# Skechers Design Center and Executive Offices

Final Environmental Impact Report  
SCH # 2015041081

**Certified January 31, 2018**

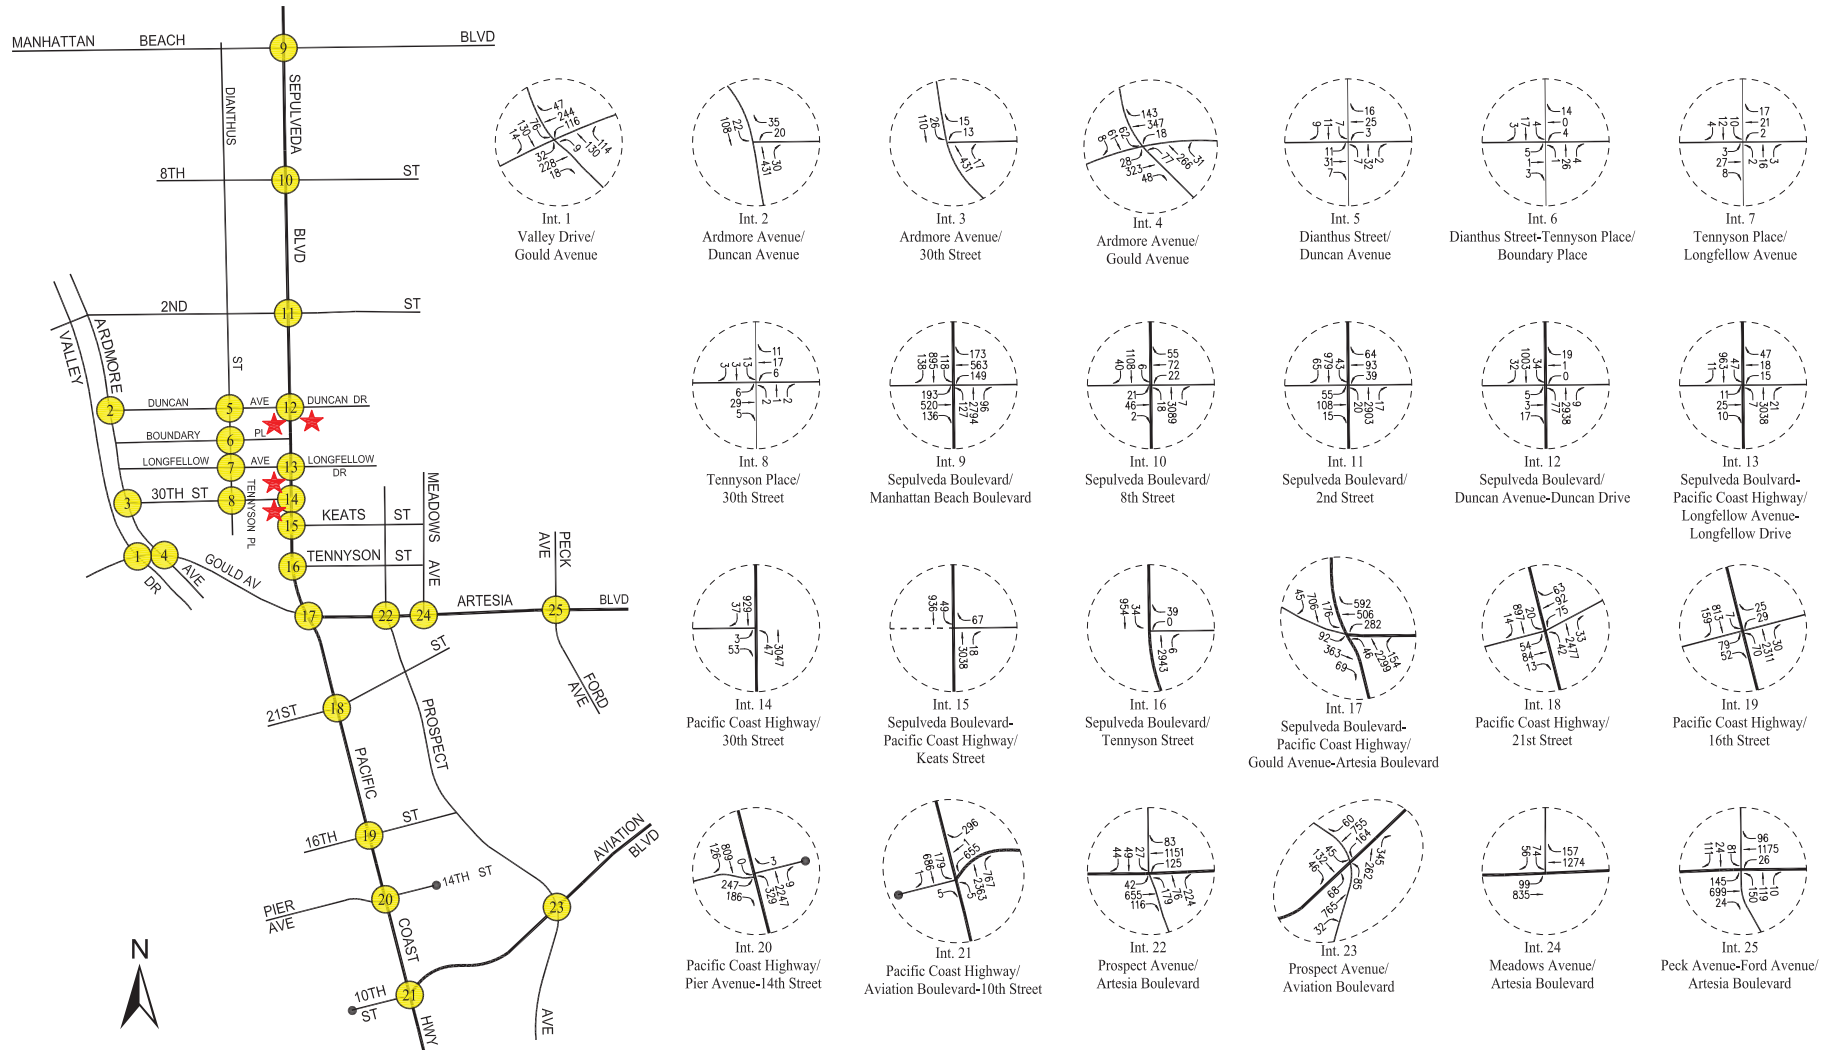
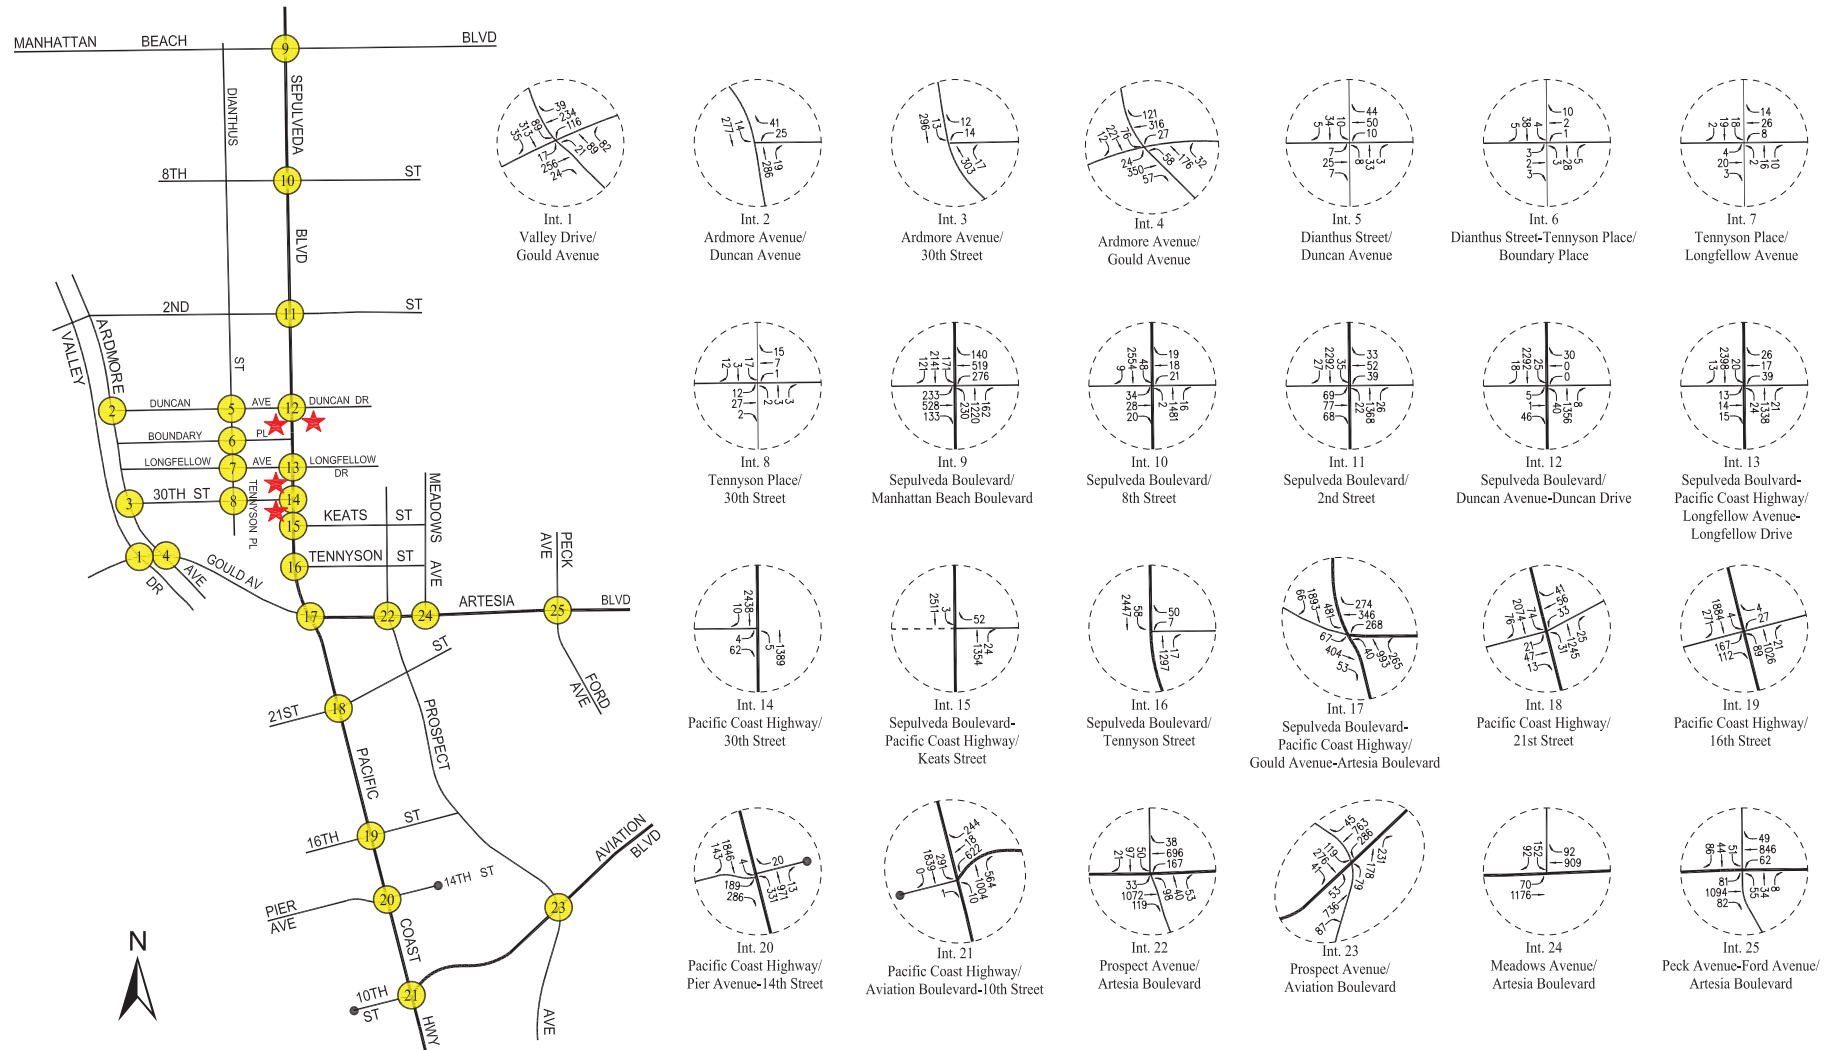
Figure 4.12-1 (page 299) and Figure 4.12-2 (page 300) require revision since they are labeled as "Existing Weekday AM/PM Peak Hour Traffic Volumes", but are actually the "Related Projects Weekday AM/PM Peak Hour Traffic Volumes". LLG's August 25, 2016 traffic analysis, as correctly contained as Appendix F of the Skechers Design Center and Executive Offices Draft EIR, contains the correct existing weekday AM/PM peak hour traffic volume figures (refer to Figures 5-1 and 5-2, on pages 44 and 45 of Appendix F of the Draft EIR).

The commenter notes that Figures 4.12-1 and 4.12-2 require revision, as they are labeled "Existing Weekday AM/PM Peak Hour Traffic Volumes," but are actually the "Related Projects Weekday AM/PM Peak Hour Traffic Volumes." The commenter notes that Figures 5-1 and 5-2 in Appendix F contain the correct existing weekday AM/PM peak hour traffic volume figures.

Potential Haul Route Overview

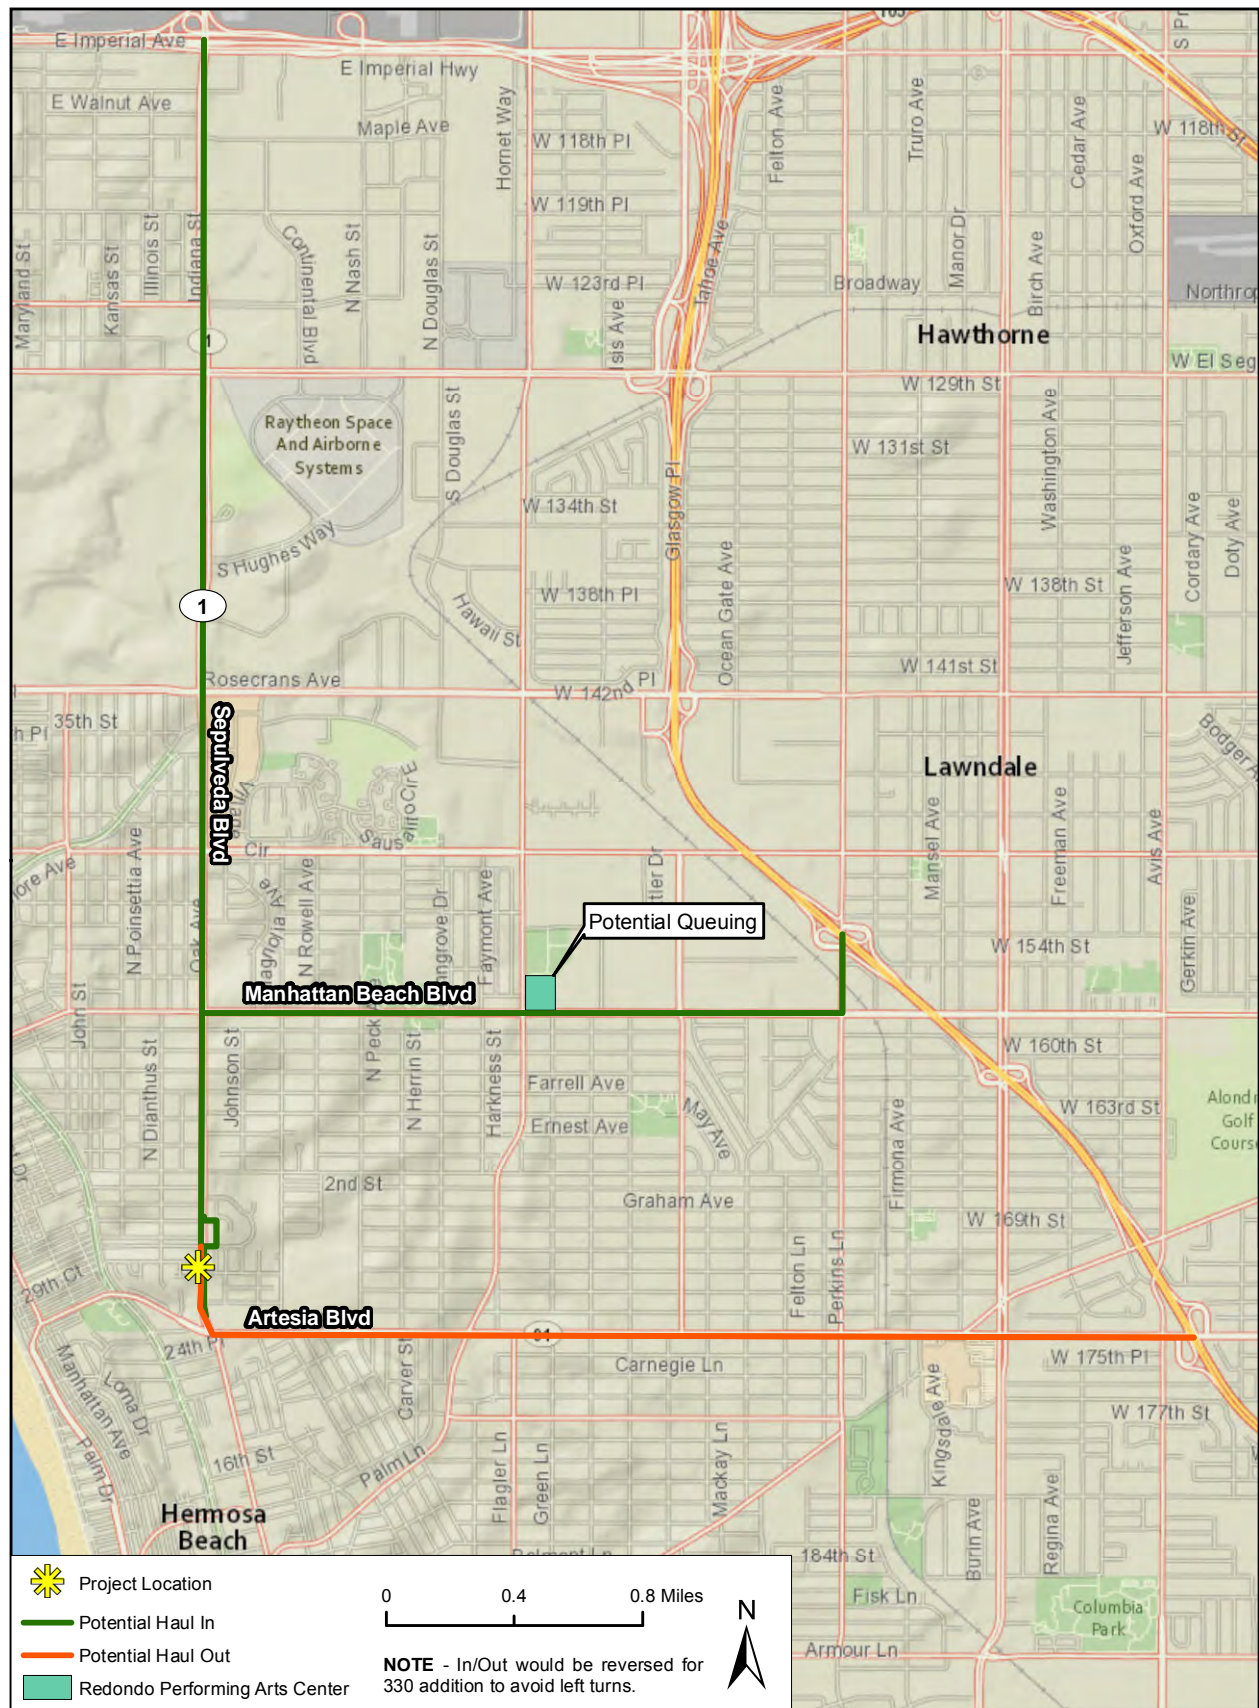
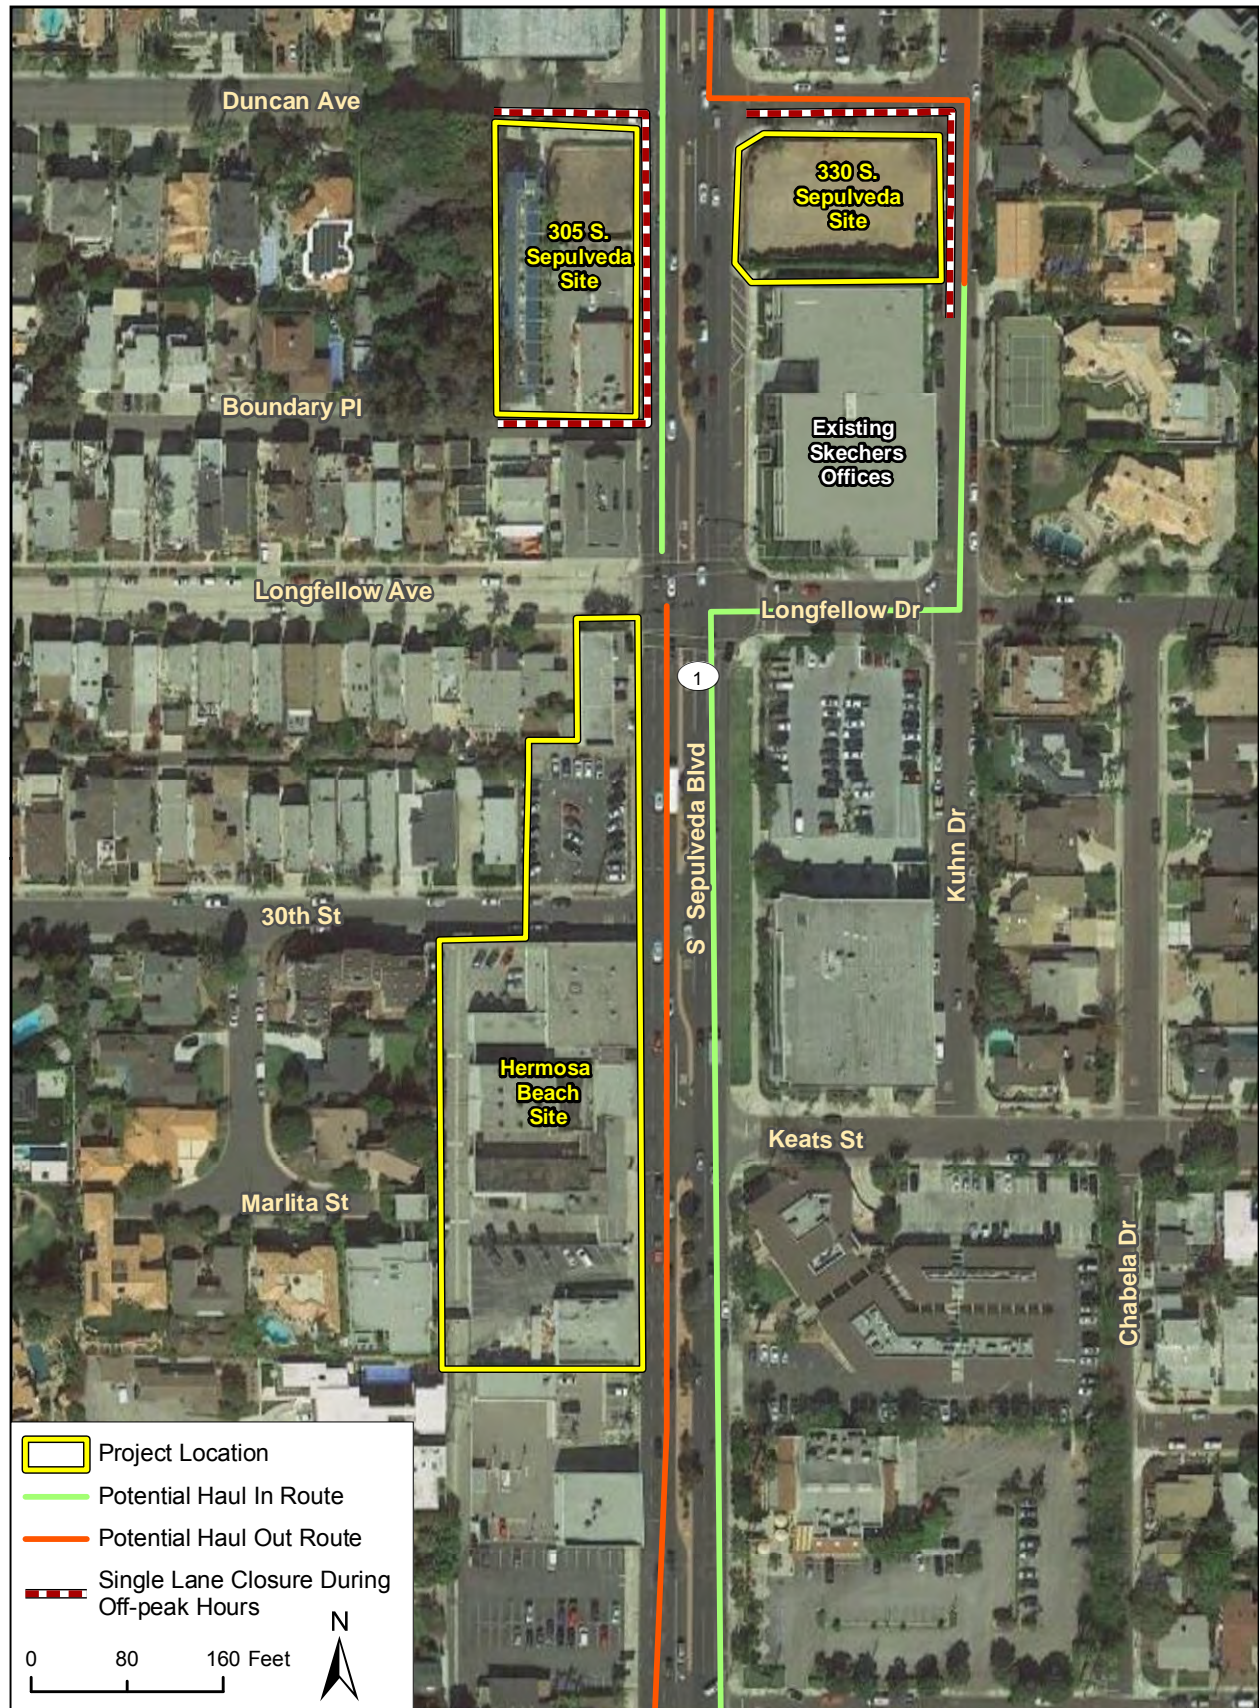
**Figure 4.12-3 (Potential Haul Route Overview) and Figure 4.12-4 (Potential Travel Lane Closures)**

Both Figure 4.12-3 (page 316) and Figure 4.12-4 (page 317) require revision. Figure 4.12-3 should be revised to show the outbound haul route (northbound) from the 330 S. Sepulveda Boulevard site to the I-105 Freeway, as well as the inbound haul route (westbound along Artesia Boulevard) to the 330 S. Sepulveda Boulevard (Manhattan Beach) site. Figure 4.12-4 needs to be revised to indicate a potential periodic single lane closure along the west side of SR-1 during off-peak hours adjacent to the Hermosa Beach sites (i.e., along the proposed Executive Offices and Design Center project components). In addition, periodic single lane closures could potentially occur along the south side of Longfellow Avenue and 30<sup>th</sup> Street for the Hermosa Beach building sites.

The commenter notes that Figure 4.12-3, *Potential Haul Route Overview*, requires revision to show the outbound haul route from 330 S. Sepulveda Boulevard to Interstate 105, and the inbound haul route to 330 S. Sepulveda Boulevard via westbound Artesia Boulevard. The commenter also notes that Figure 4.12-4, *Potential Lane Closures*, should be revised to indicate potential periodic single-lane closures along the west side of SR 1 during off-peak hours adjacent to the Hermosa Beach site, as well as potential periodic single-lane closures along the south side of Longfellow Avenue and 30<sup>th</sup> Street.
